Re: Project Narrative for Tango Townhomes located at:

400 Granite St. Frisco, CO 80443

Tango Townhomes Narrative

Response to comments from the Sketch Plan Meeting:

SITE PLAN

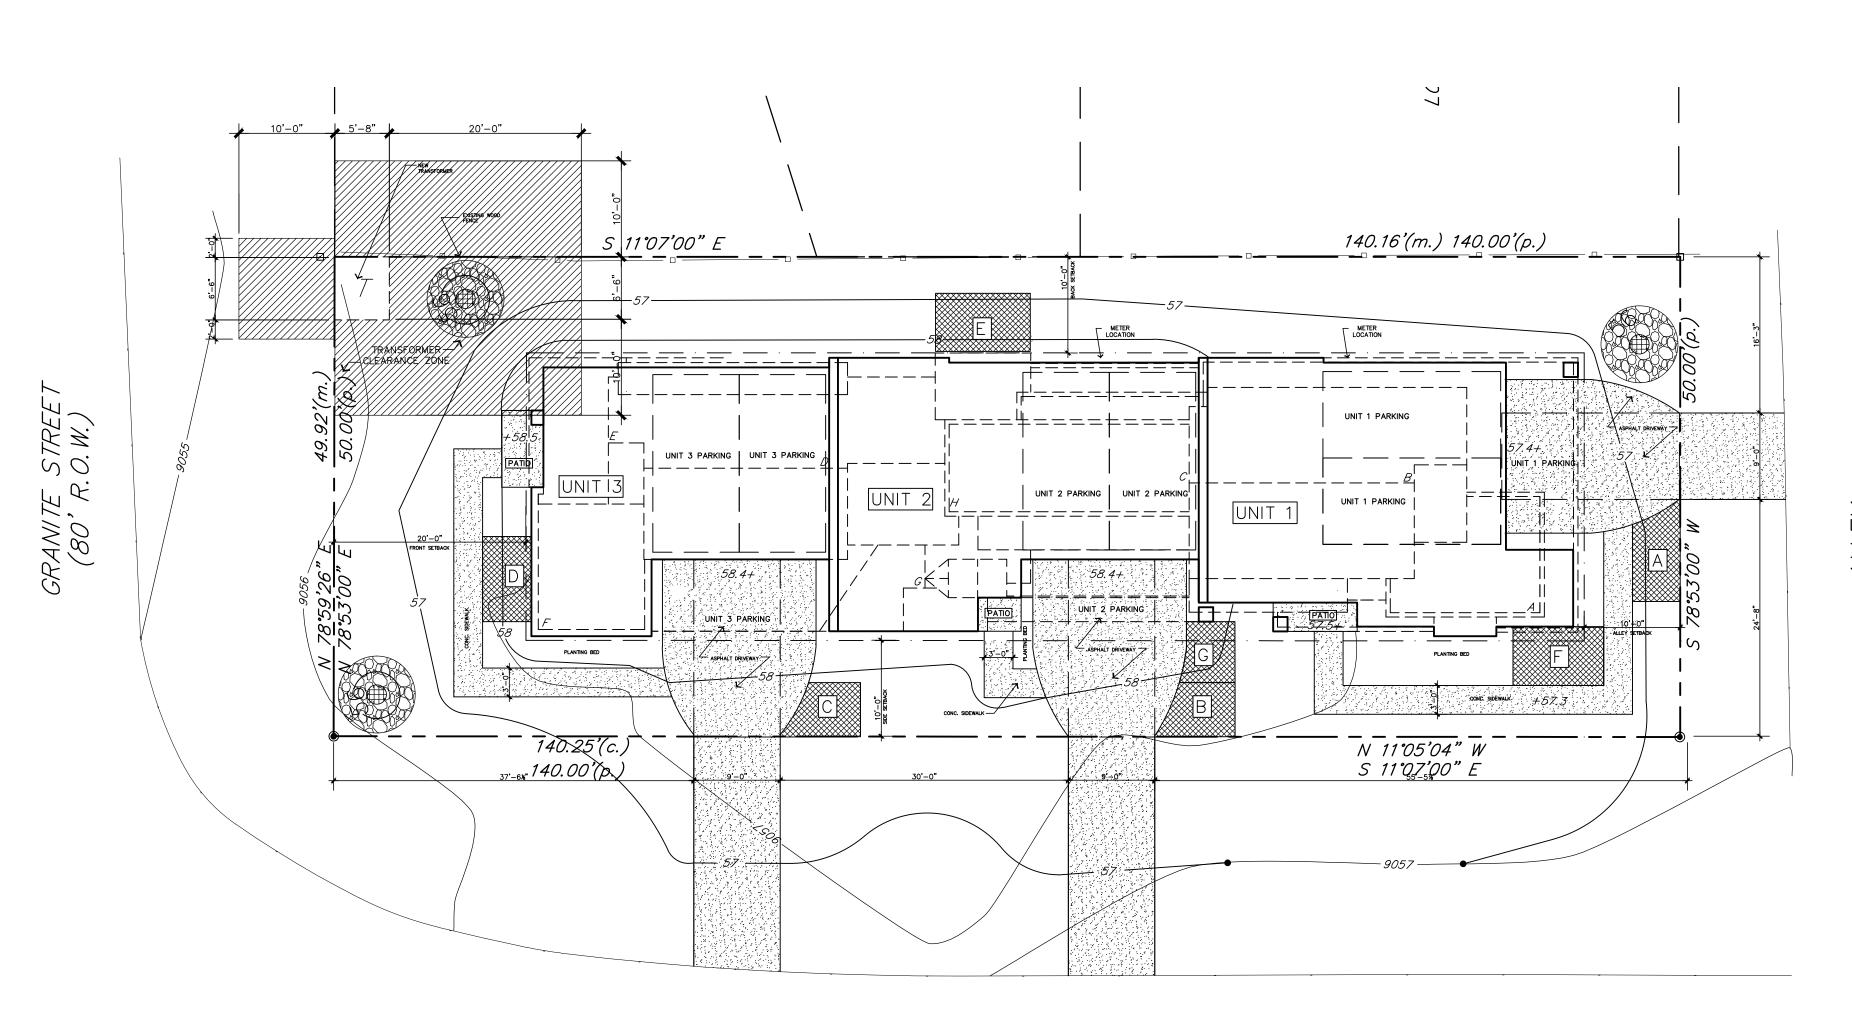
"Uncovered Deck snow storage needs to be added."

Ploenhaus Response: Snow storage calculations have been added to the Site plan & Landscape plan

LANDSCAPE PLAN

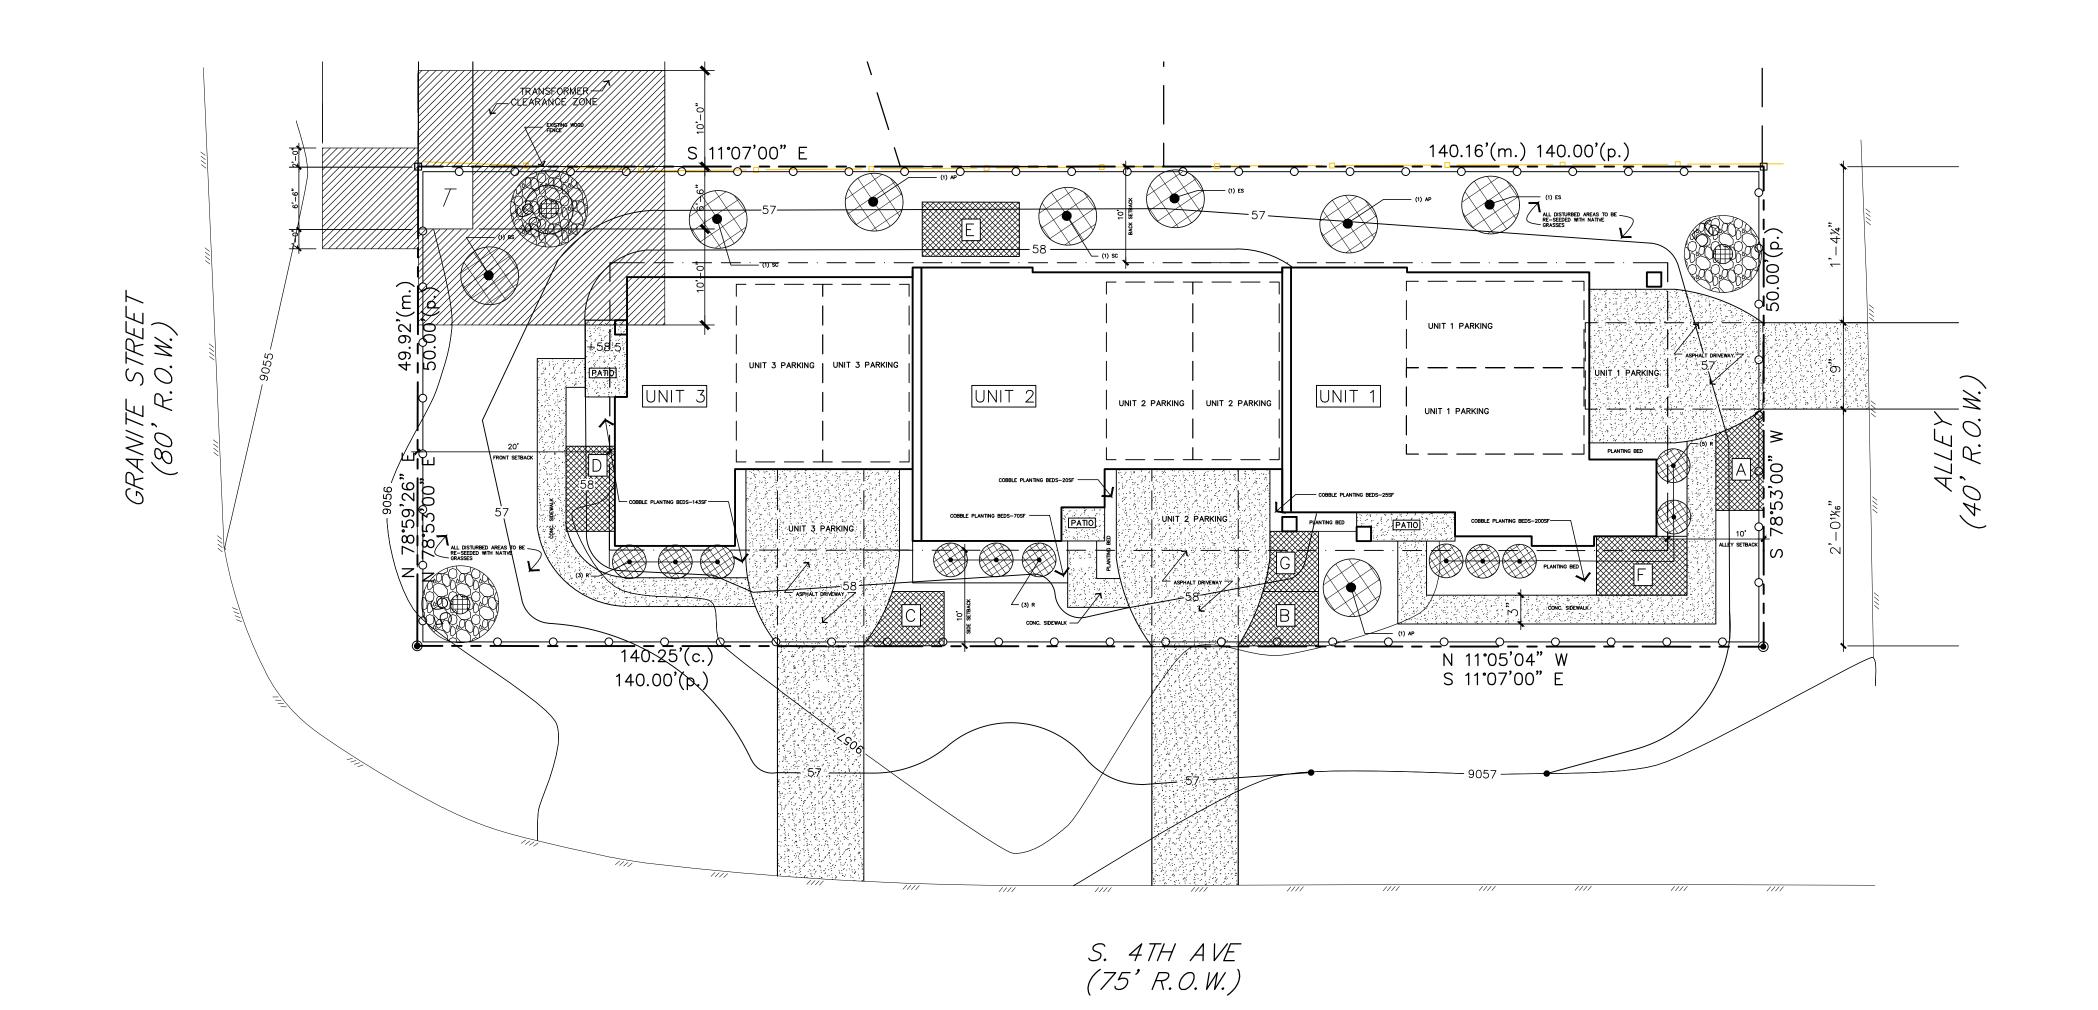
"404 Granite owner: Please protect privacy between their unit and unit 2. Particularly master bedroom level."

Ploenhaus: The Master bedroom deck has been moved to the front of Unit 2. We have also replaced the former sliding door with high windows for privacy. All existing trees will remain. Additional trees have been added to the back property line to also help with privacy.

ROOF PLAN NORTH

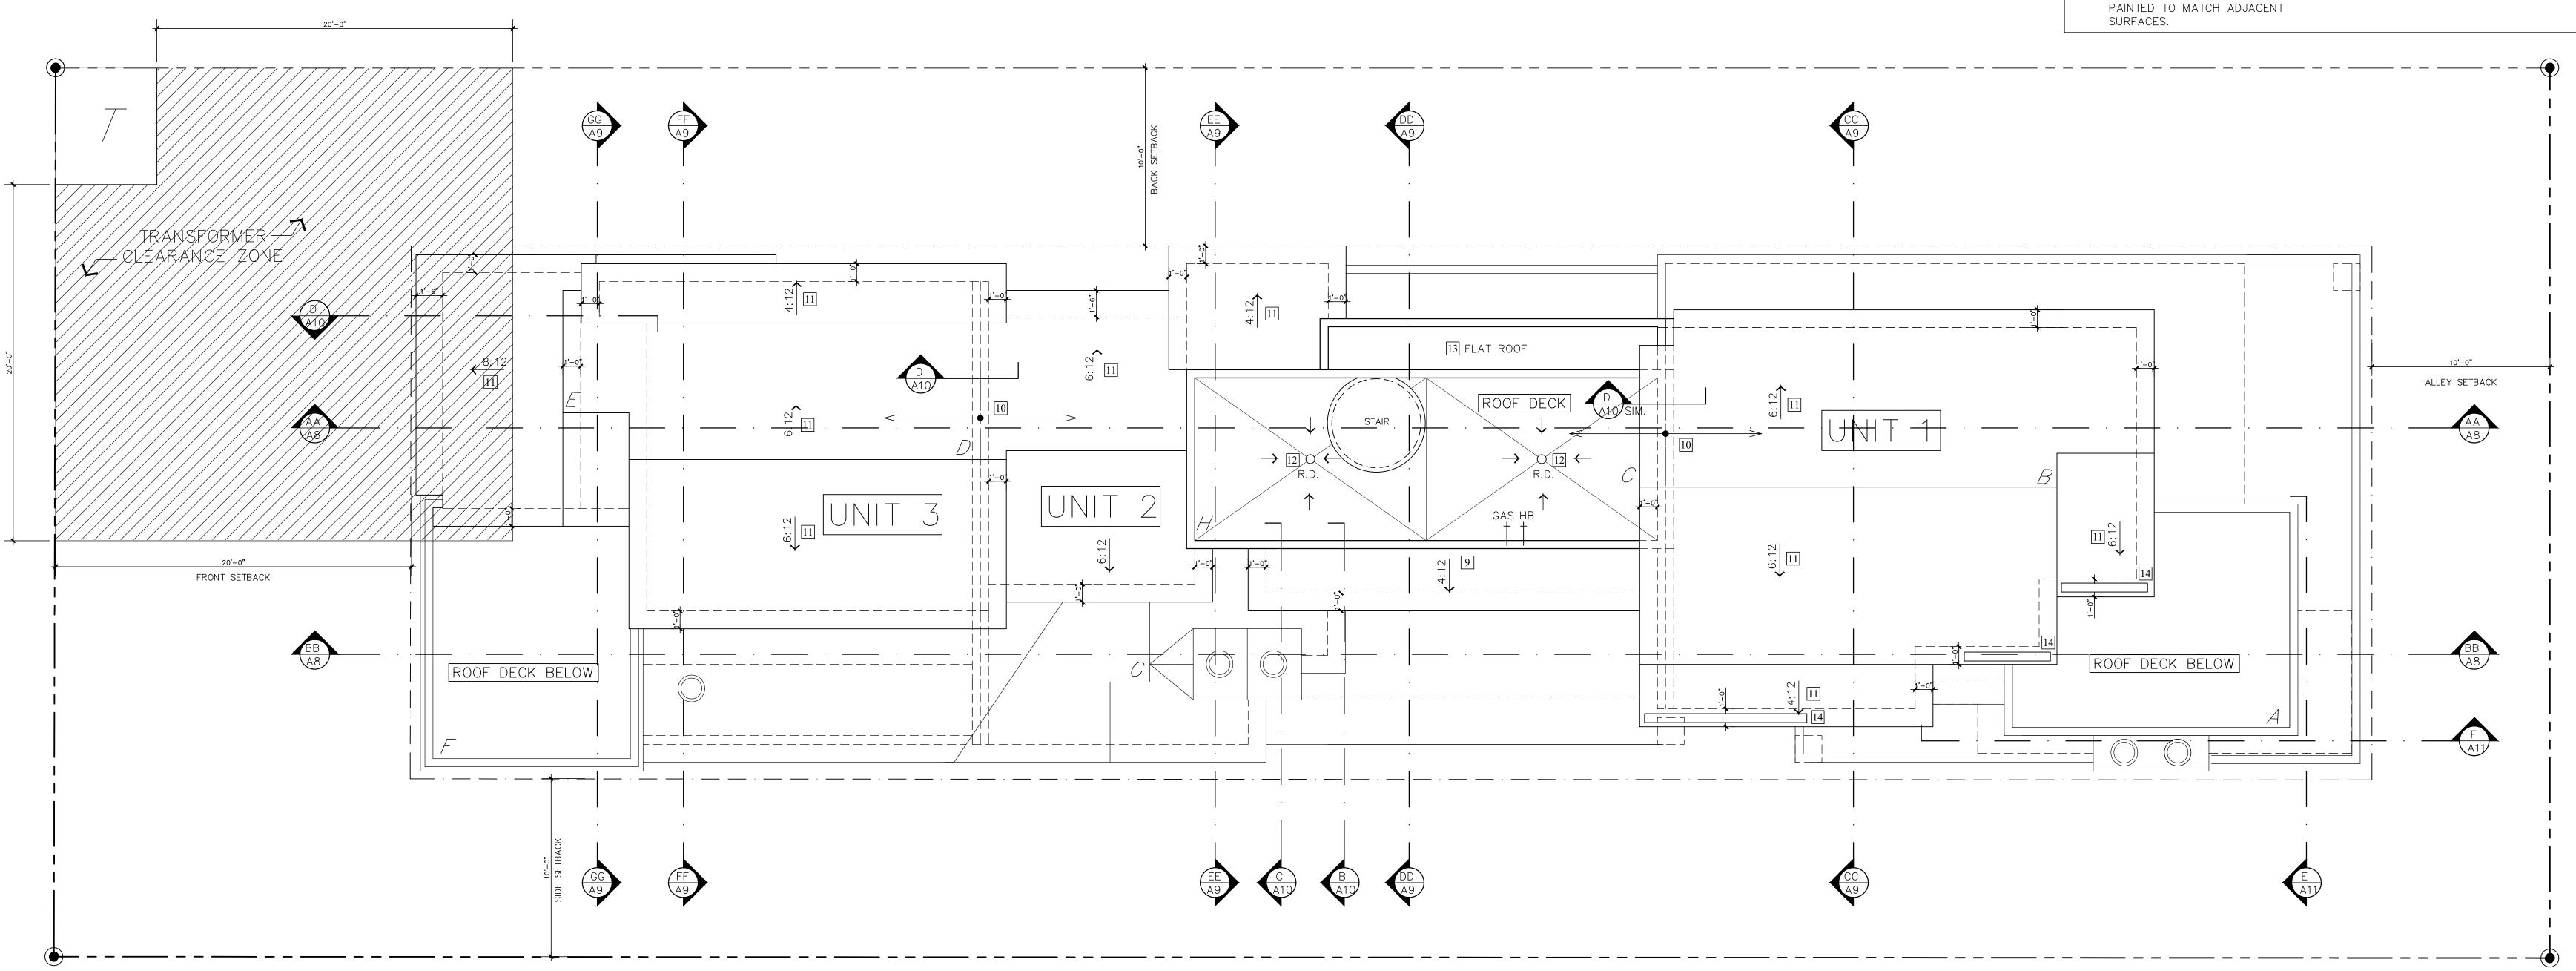
"Rooftop snow retention needs to be added to areas shedding on decks and driveways."

Ploenhaus: Snow Retention has been added to the roof plan in all these areas.

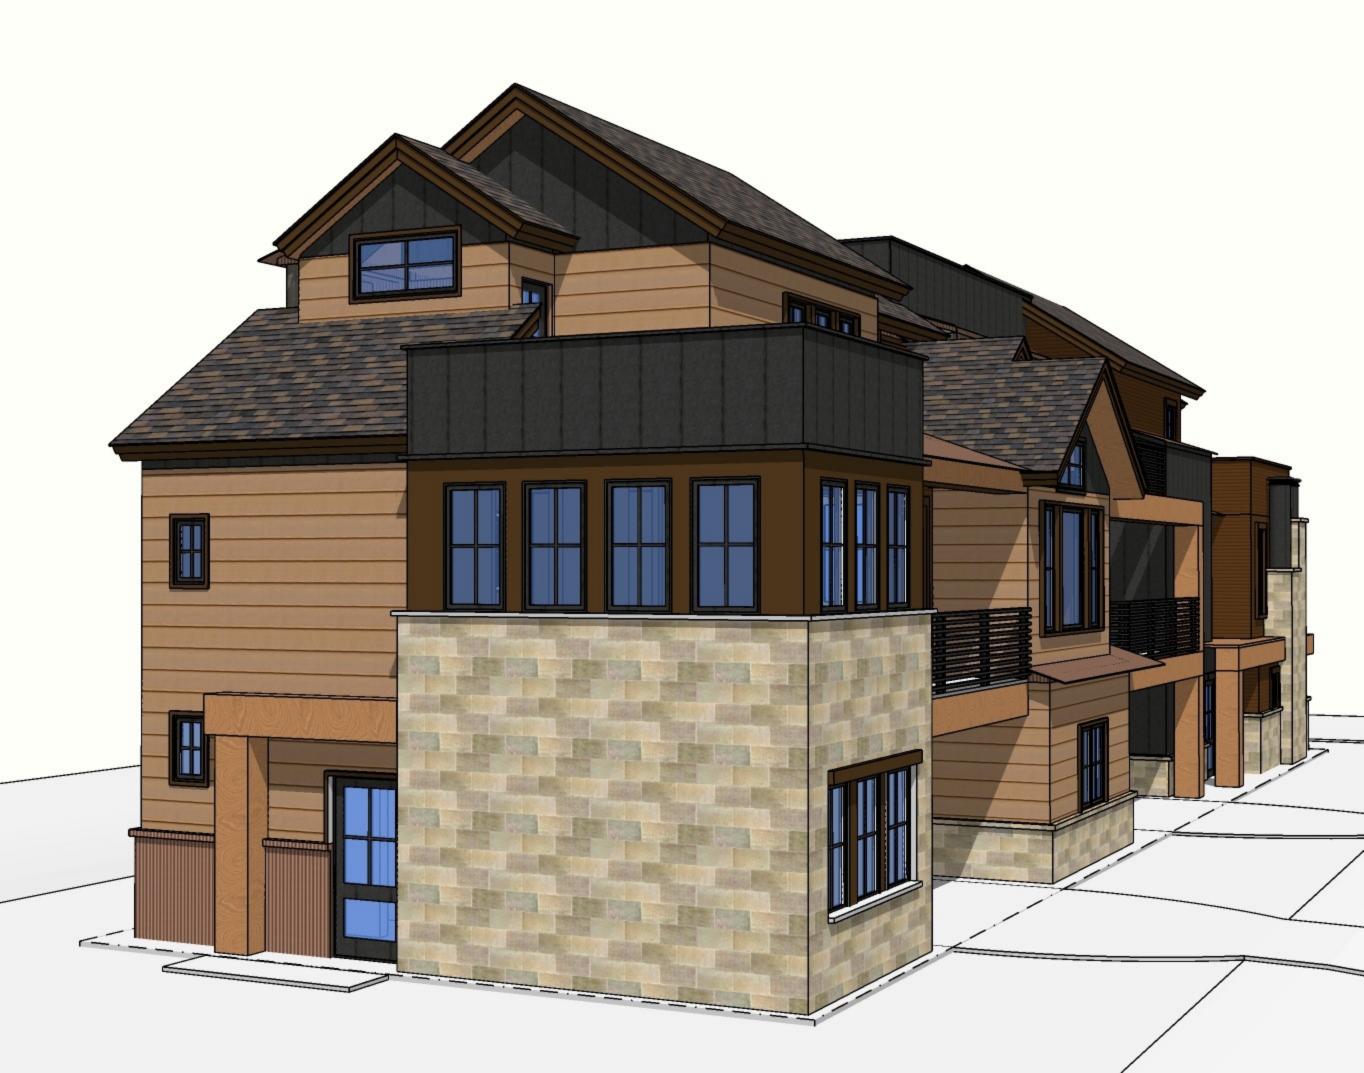
"Add grout to the Material board"

Ploenhaus: Grout color has been added to the Material Board.
